Re: Initial Submission Review – Lamar Landing Master Plan
Application Number: **DA-2239-00**
Case Numbers: **2020-7005-00**

Initial Submission Review

E470 PHA RIGHT OF WAY	
REVISIONS	DATE: March 31, 2017	BY DATE
	09/16/09 Corrected Parcel 83 and 83A hatching	Scale: 1" = 400 FT
	JOB NO:	Field Book:
	SHEET: AER-031-PLAN	Surveyed by:
		Calculated by: LEL
		Drawn by: LEL
		Checked by: LEL

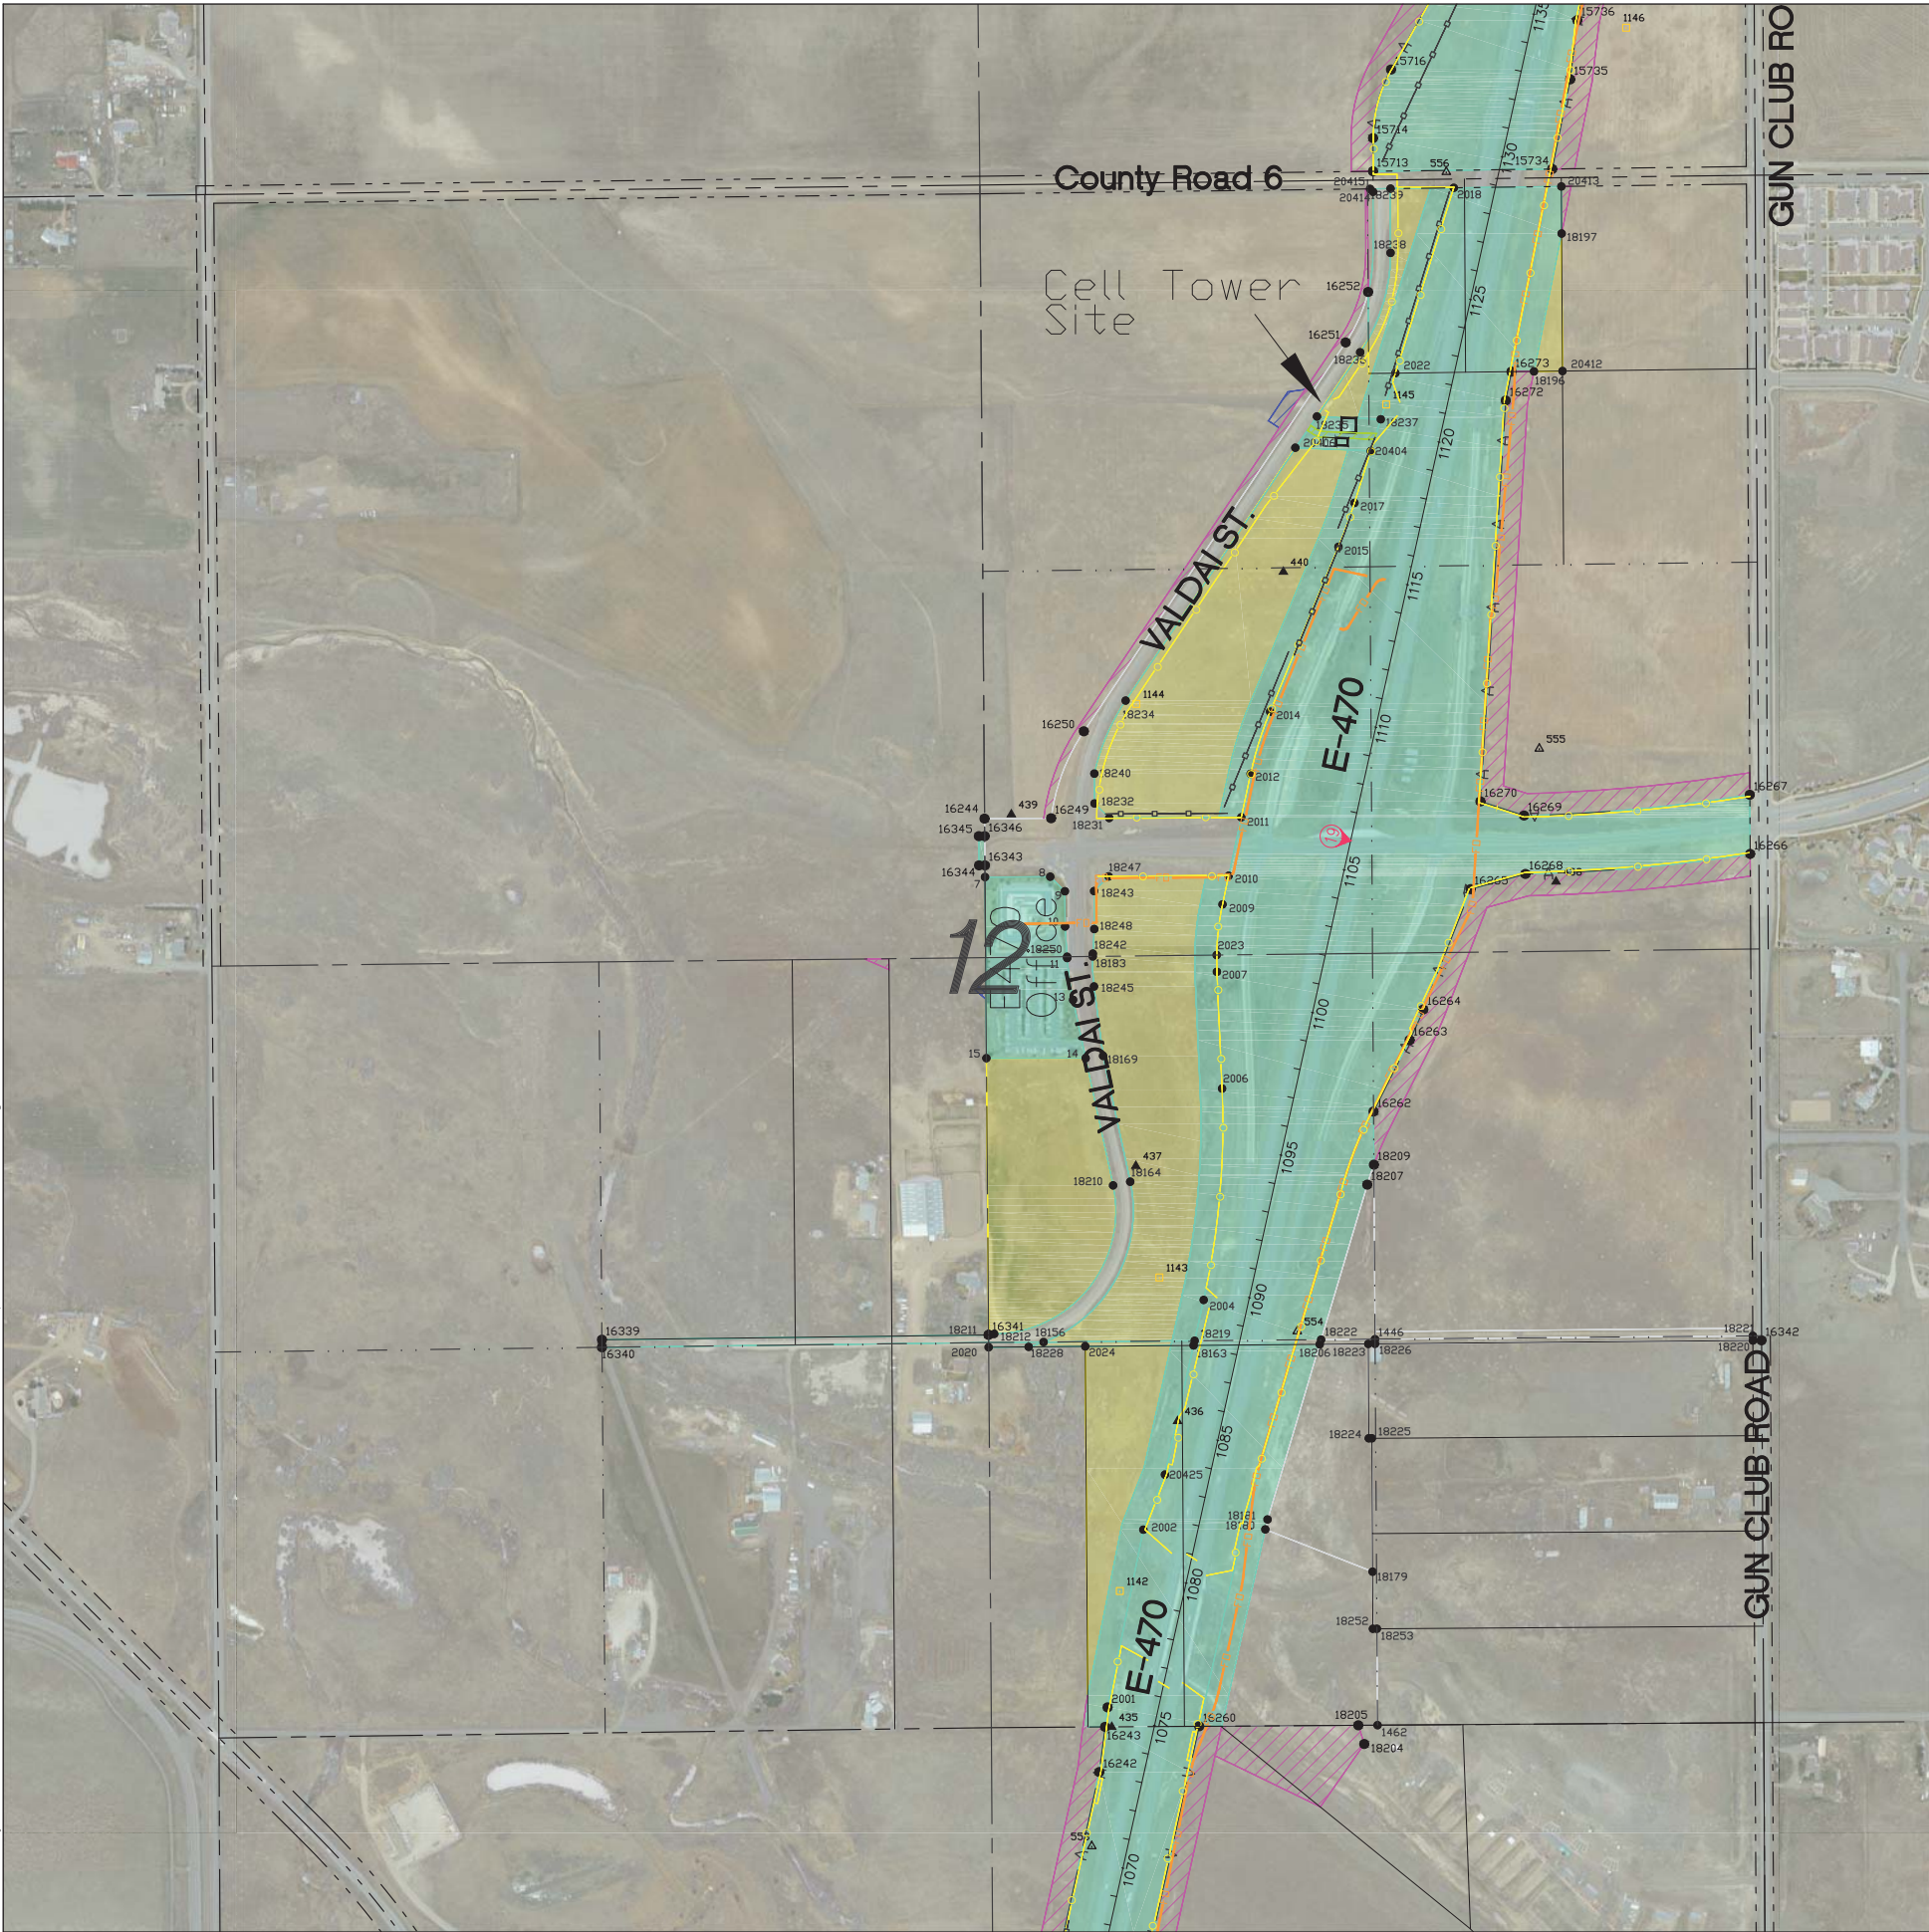
- Clearly label the ROW and MUE on the appropriate sheets, please see attached ownership map.
- Stormwater discharge to the E-470 ROW will need to be treated prior to release and will be limited to historic rates tributary to E-470.
